PLANNING COMMISSION

Case No. P16-29

699 W. Liberty Street

Subject: Site Plan & TCOV Certificate of Appropriateness – Building Alterations

EXTERIOR ELEVATIONS

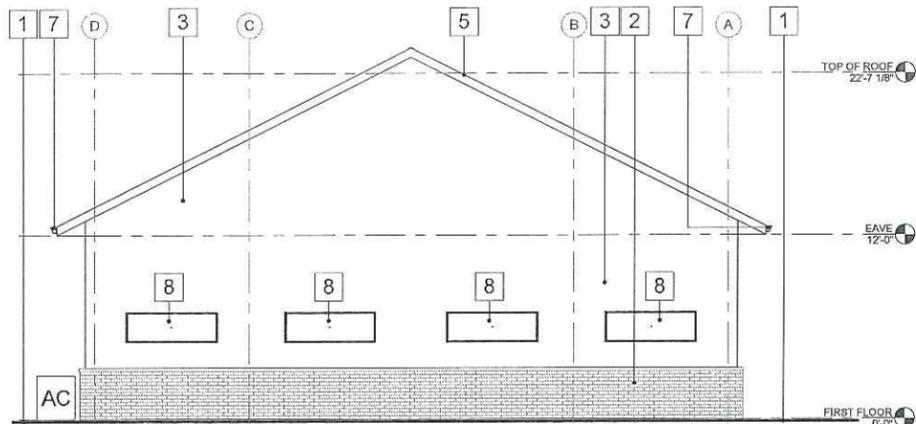
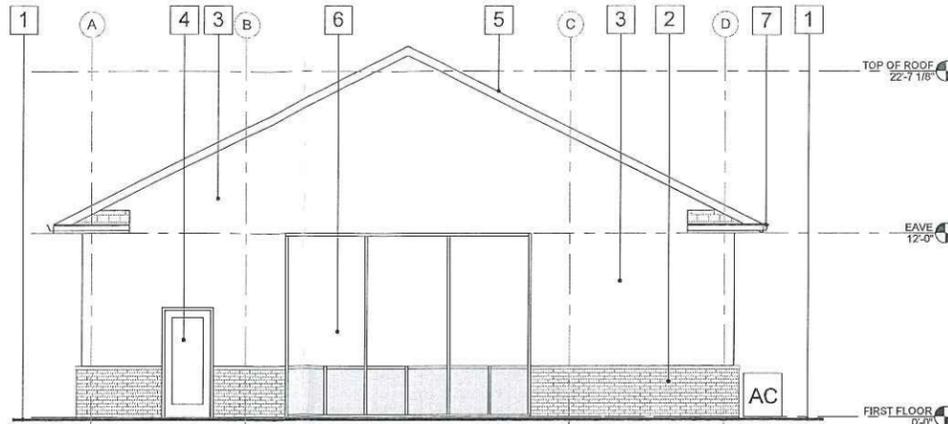
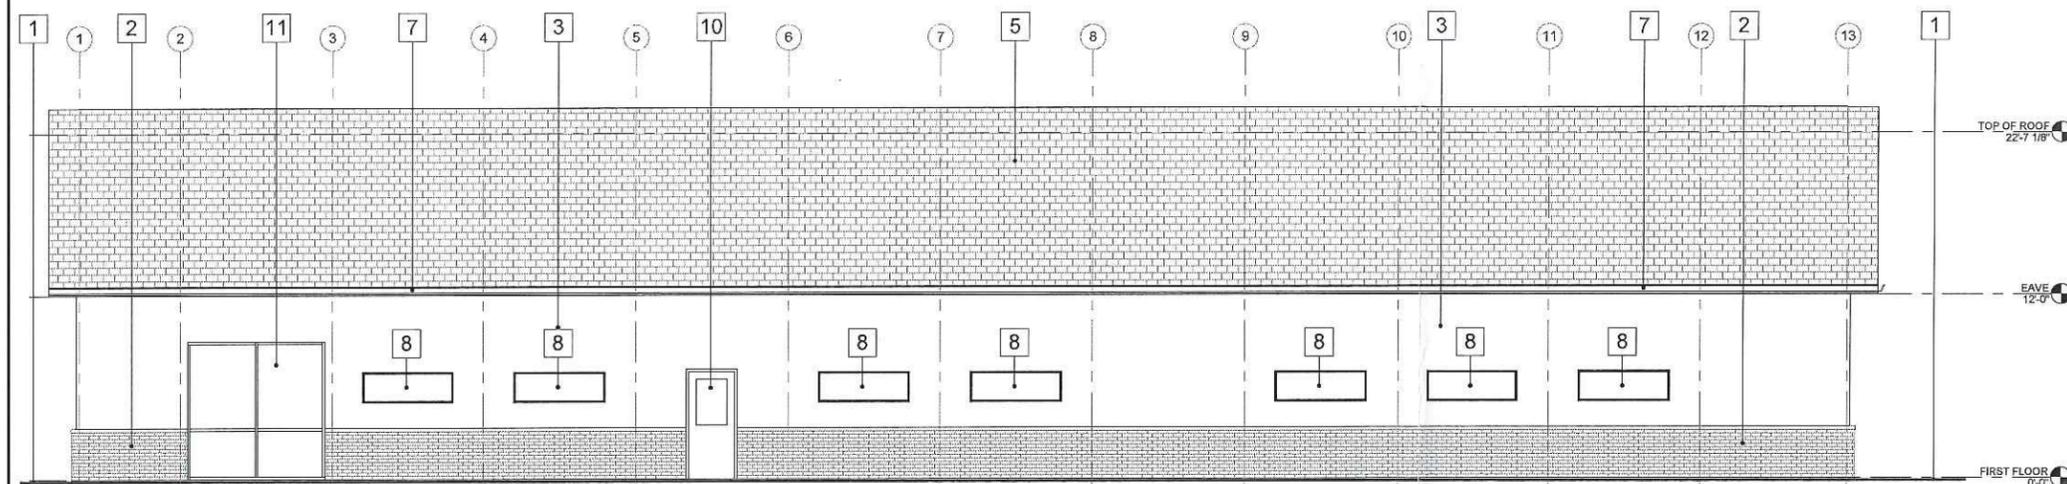
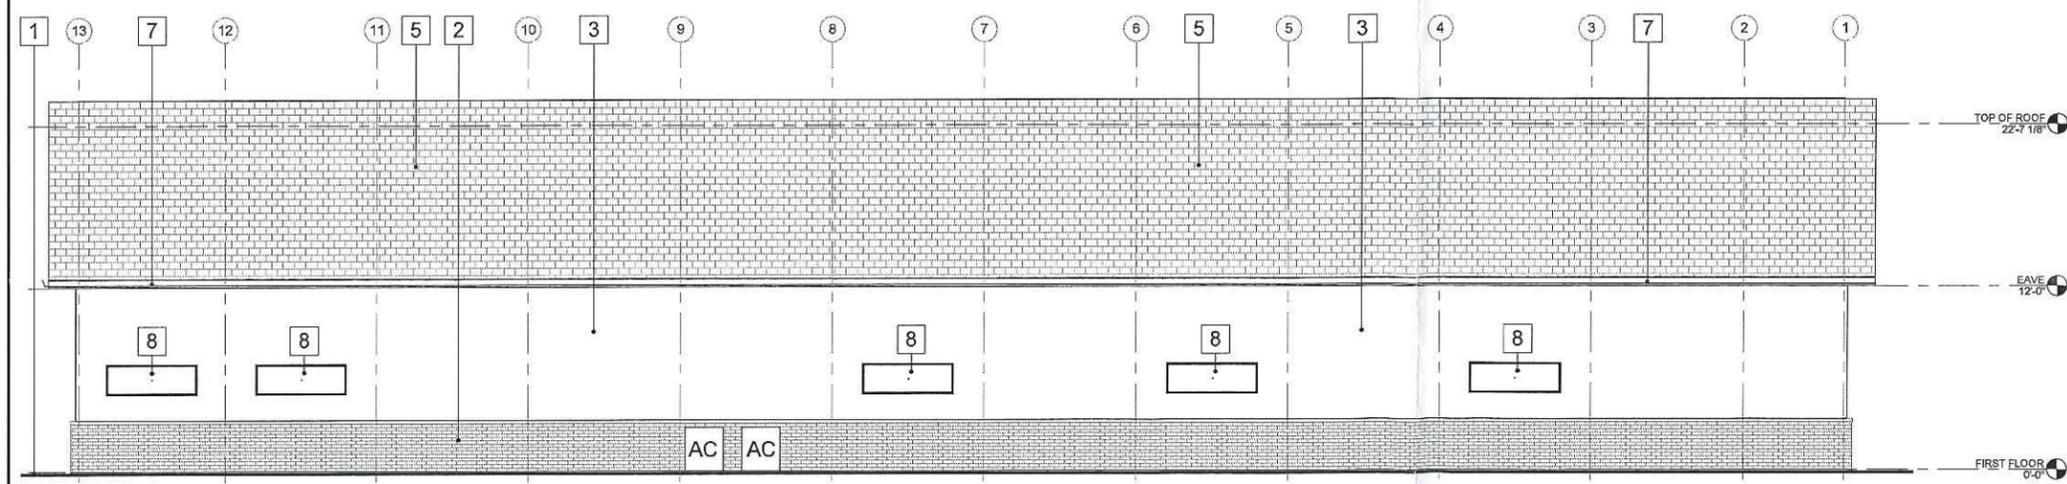
The proposed facades remove all the texture and detail from the existing façade by removing the vinyl shake siding, window/door frame and eave trim details from the façade and replacing with EIFS of an indeterminate color. This is a significant change from the detailing and aesthetics of the existing building façade design. Both the Site Plan and TCOV design guidelines discourage the removal of distinguishing architectural features. Additionally, the Site Plan design guidelines discourage the use of unbroken expanses of EIFS. The EIFS is proposed to replace the vinyl shake siding and window/door frame detailing, but not incorporate any color change or surface dimensionality through the use of reveals, pilasters, etc. Though, the proposal does retain the brick wainscoting along the facades, which does reduce the expanse of EIFS.

In order to better adhere to the TCOV and Site Plan design guidelines, staff recommends the applicant either provide more surface relief to the proposed expanses of EIFS or simply determine whether the proposed new windows and doors could be incorporated in to the building without requiring the removal of the existing vinyl shake siding and overall detailing.

1. In order to better adhere to the TCOV and Site Plan design guidelines, the applicant works with staff to either provide more surface relief to the proposed expanses of EIFS or simply determine whether the proposed new windows and doors could be incorporated to the building facades without requiring the removal of the existing vinyl shake siding and overall detailing.
2. Subject to review and approval of building permits from the City of Medina Building Department.
